**DOMINION NUCLEAR CONNECTICUT, INC.**  
**MILLSTONE POWER STATION UNIT 3**  
**RESPONSE TO REQUEST FOR ADDITIONAL INFORMATION REGARDING**  
**STRETCH POWER UPDATE LICENSE AMENDMENT REQUEST**  
**REVISED RESPONSE TO FOLLOW-UPS EEEB-08-0108 THROUGH EEEB-**  
**08-0113 TO QUESTION EEEB-07-0052**

**Stretch Power Uprate License Amendment Request**  
**Response To Request For Additional Information**  
**Revised Response To Follow-Ups EEEB-08-0108 through EEEB-08-0113 To**  
**Question EEEB-07-0052**

**NRC Question EEEB-07-0052 Follow-Up (EEEB-08-0108)**

Figure 1: Pre- and Post-SPU Environmental Temperature Profiles

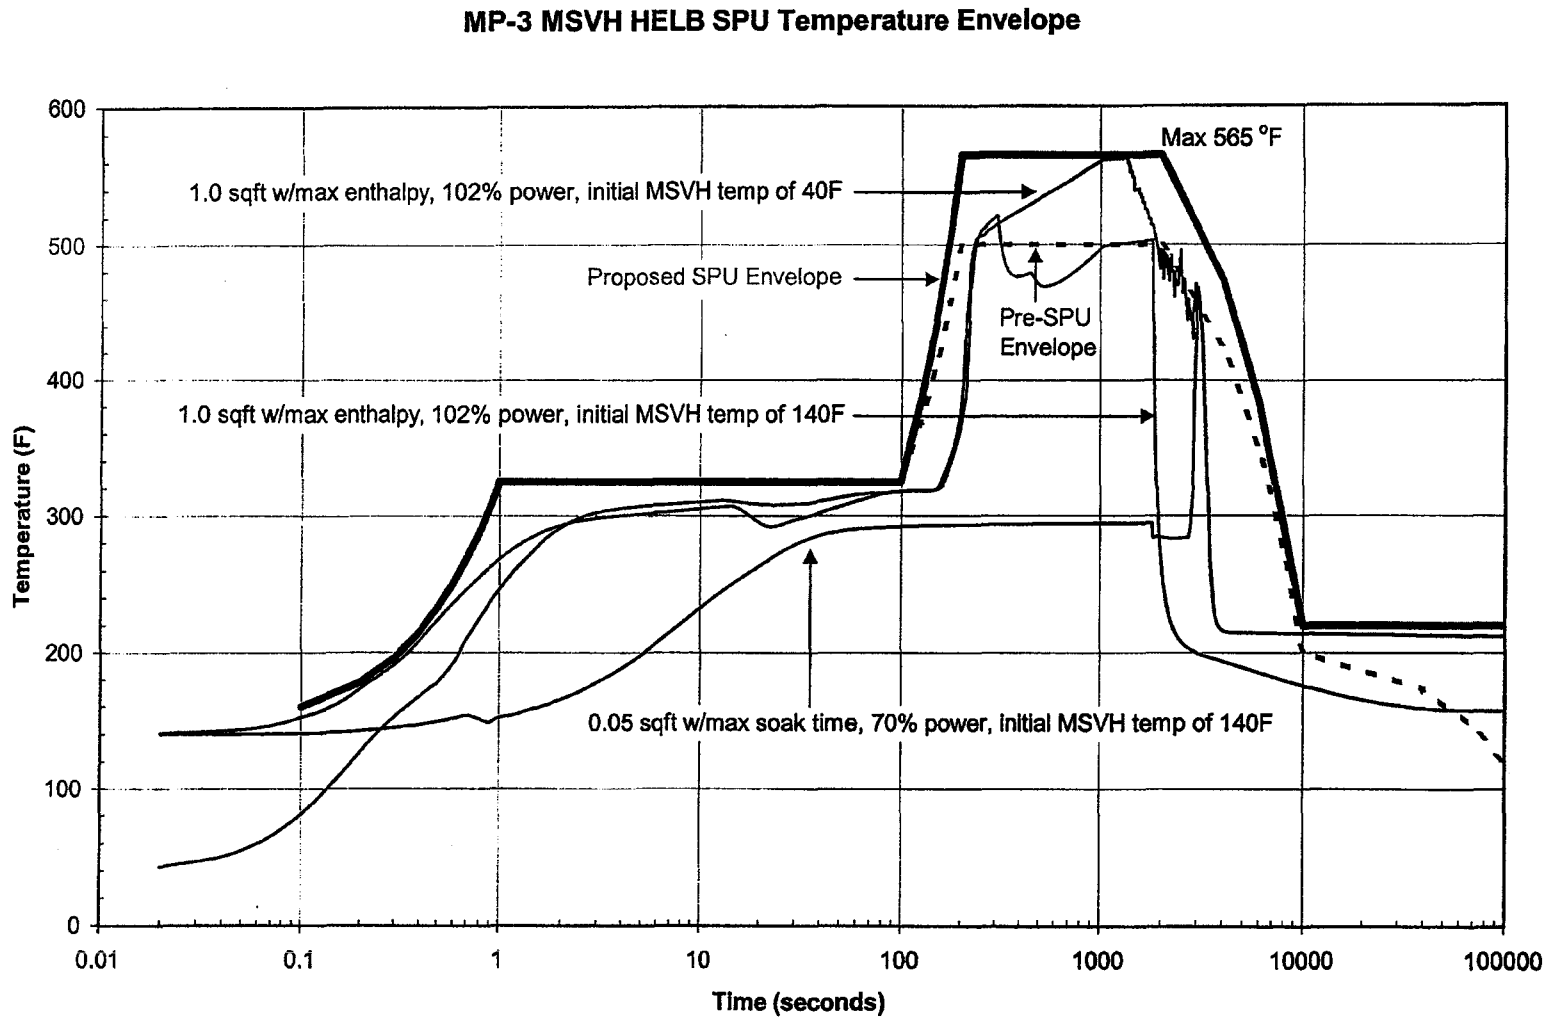
In the March 25, 2008, letter, the licensee states that the analysis for the Main Steam Valve Building (MSVB) following a main steam line break (MSLB) is performed for the duration of the component's mission time. Specify the mission time and function for each of the affected components in the MSVB. Describe the effects of the increased temperature and pressure on the affected components. In addition, explain, in detail, the assumptions and methodology used to evaluate the components. Provide a comparison of the pre-stretch power uprate (SPU) and SPU environmental temperature and pressure profile. Also, provide the detailed environmental qualification (EQ) evaluations and calculations for the ASCO solenoid valves, NAMCo limit switches, Rosemount pressure transmitters, Limatorque motor-operated valves and solenoids associated with Sulzer main steam isolation valves (MSIVs) and ITT actuators.

Provide the worst-case breaks and their impact on the EQ components for the MSVB EQ analysis.

A comparison of the enveloping pre- and post-SPU environmental temperature profiles is provided in Figure 1. The current EQ pressure profile envelopes post-SPU pressure profiles for all cases analyzed. Therefore there is no change to the EQ pressure profile. The enveloping EQ pressure profile is shown in Figure 2.

Figure 3: Pre-SPU Temperature Profiles for ASCO Solenoid Valves

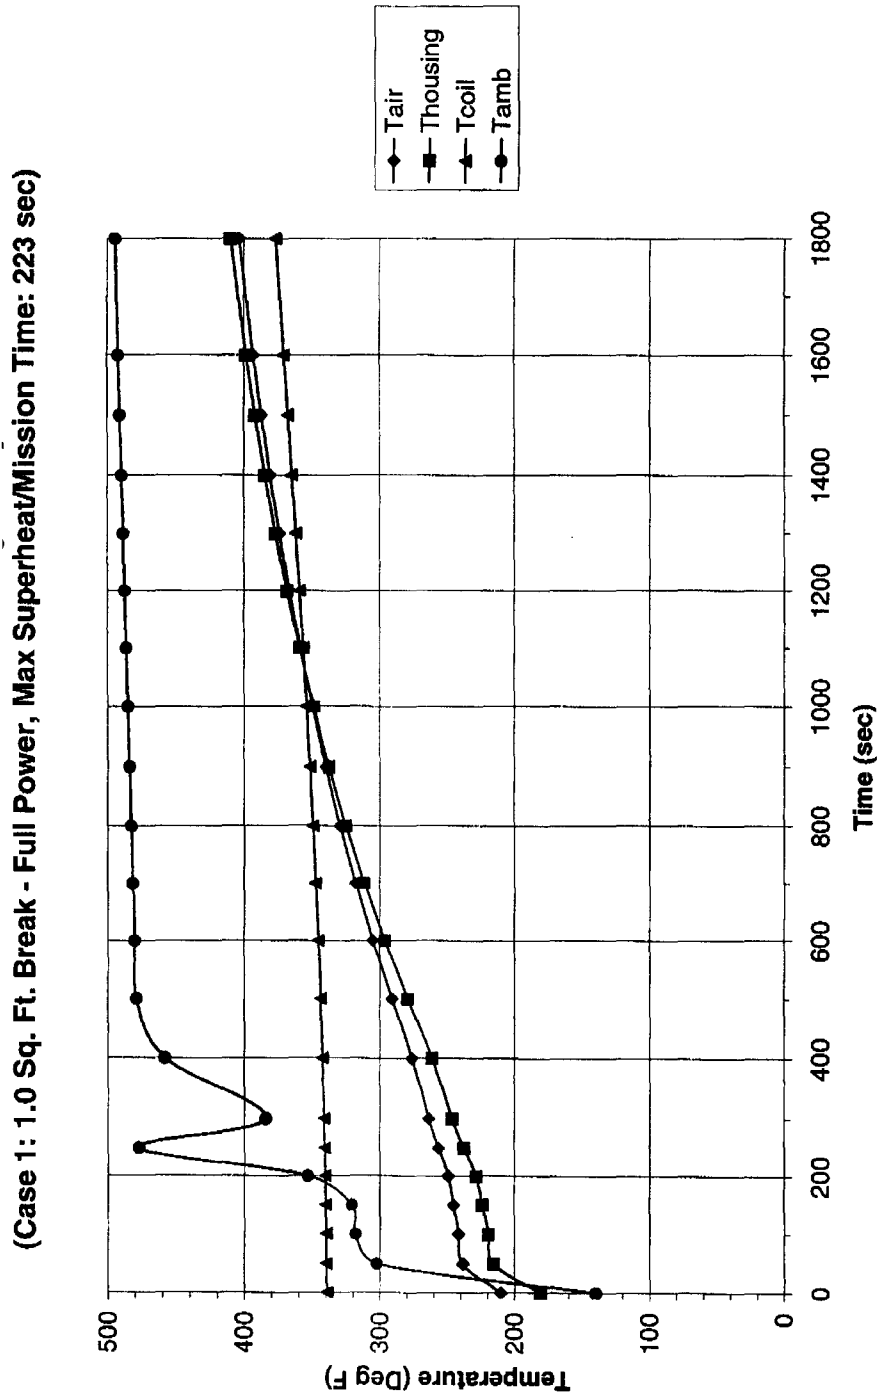
In the March 25, 2008, letter, the licensee states that the outside temperature (i.e. component casing temperature) of the equipment, instead of the internal temperature of the equipment, was conservatively compared with the component qualification temperature. Provide a basis for why the outside temperature is conservative for the affected EQ components.

Pre-SPU ASCO solenoid valve thermal lag analysis used a bounding environment temperature profile (i.e., 1.0 ft<sup>2</sup> break size, 102% NSSS power level, maximum enthalpy) and a maximum mission time of 1800 seconds. This maximum mission time bounds the MSI times for all break sizes analyzed. The analysis also assumes that the valves are energized to account for coil heat generation. The peak temperatures were determined for the solenoid coil, air gap and coil housing. The maximum post-SPU coil temperature is calculated by conservatively adding the temperature difference between the bounding pre- and post-SPU environment temperature profiles to the calculated peak pre-SPU coil temperature (See note on Figure 3). The peak temperature for pre-SPU environment temperature profile for solenoid valve qualification is 494.2°F (See Figure 3, curve labeled Tamb). The peak temperature identified in the post-SPU environment temperature profile for solenoid qualification is 562.2°F (See Figure 1, curve labeled 1.0 sqft w/max enthalpy, 102%, initial MSVB temperature of 140°F). The pre-SPU solenoid coil temperature at the maximum mission time (1800 seconds) is 377°F (See Figure 3, curve labeled Tcoil). The post-SPU peak coil temperature as identified in the note on Figure 3 is 445°F and remains below the 450°F ASCO solenoid valve qualification temperature.

Note: post-SPU peak coil temperature = pre-SPU peak coil temperature + temperature difference between bounding pre- and post-SPU environmental profiles

$$= 377^{\circ}\text{F} + (562.2^{\circ}\text{F} - 494.2^{\circ}\text{F}) = 377^{\circ}\text{F} + 68^{\circ}\text{F} = 445^{\circ}\text{F}$$

Figure 6: Post-SPU Limatorque Motor Temperature Profiles (with insulation)

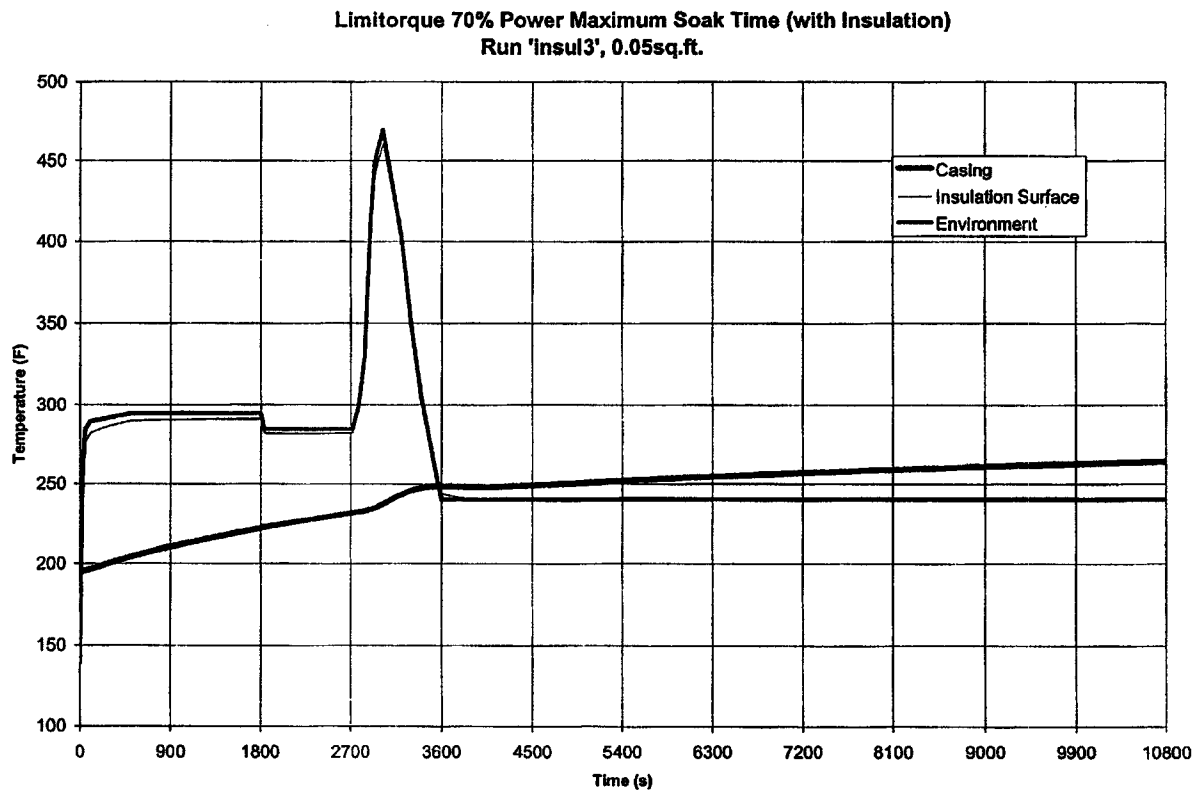
During the March 31, 2008, teleconference, the licensee stated that due to the temperature increase in the MSVB, a design change (enclosing the Limatorque motors with insulation) will be required to maintain the qualification of the motors. Describe the design change in detail and provide a detailed evaluation justifying how this new design, (enclosing the motors with insulation), does not impact the original qualification configuration of the Limatorque motors. In addition, provide a schedule for implementing the aforementioned design change.

Do the motor-operated valves installed in the MSVB use magnesium rotors? If yes, then evaluate the impact of high temperatures on the motors due to the SPU to ensure that these motors do not experience the failure mechanism identified in Information Notice 2006-26 and industry operating experience.

The peak MSVB environmental temperatures for all eight cases occur well within 3,600 seconds after break initiation. Therefore, the analysis was run for a period of 10,800 seconds (3 hours). Although the environment temperature drops rapidly after one hour, the analysis assumed a 240.5°F temperature for the remaining portion of the transient. In addition to the external heat flux from the harsh environment to the motor casing, the analysis assumed conductive heat flux from the valve to the motor casing. Therefore comparison of the higher casing temperature to the qualification temperature is conservative. The insulated motor casing temperature at 3 hours is 265°F, which is less than the 315°F motor qualification temperature. Post-SPU temperature profiles of the ambient and the motor casing are provided in Figure 6.

insulate the motors of the 3MSS\*MOV18A/B/C/D valve operators prior to exceeding 3411 MWt. The design change will install 1.5 inch thick flexible blanket type insulation covering only the motor. The following activities support the design change process to ensure that 3MSS\*MOV18A/B/C/D will perform their intended design function under SPU MSVB HELB environment.

1. An analysis will be performed showing that the motor casing temperature will be less than the motor qualification temperature following a MSLB with the insulation installed. The analysis assumes an insulation thickness of 1.5 inches having a thermal conductivity of approximately 0.326 Btu-in/hr ft<sup>2</sup> °F. This activity is complete.
